Access Compliance Report

Public Rights-of-Way

(Pedestrian Signals)

Intersection ID: N/A	Main Street:	Cross Street: N/A	Location: N/A
ADA ID: 036D5C09275E	Signal Type: One Push Button-Non APS	Overall Compliance: No	Severity Score: BTN 1: N/A BTN 2: N/A No BTN: N/A
Codes/Mitigation Info/Possible Solution		Field Measurements/Component Compliance

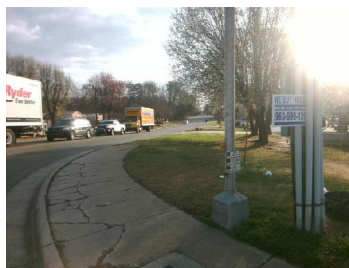
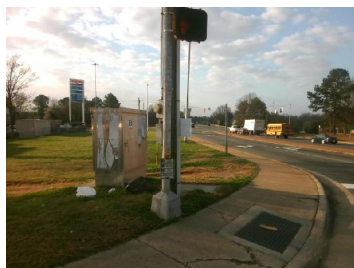
PROW/ADA: R404.2, R404.3, R404.7.2

Possible Solutions: Remove and Replace Clear Space.
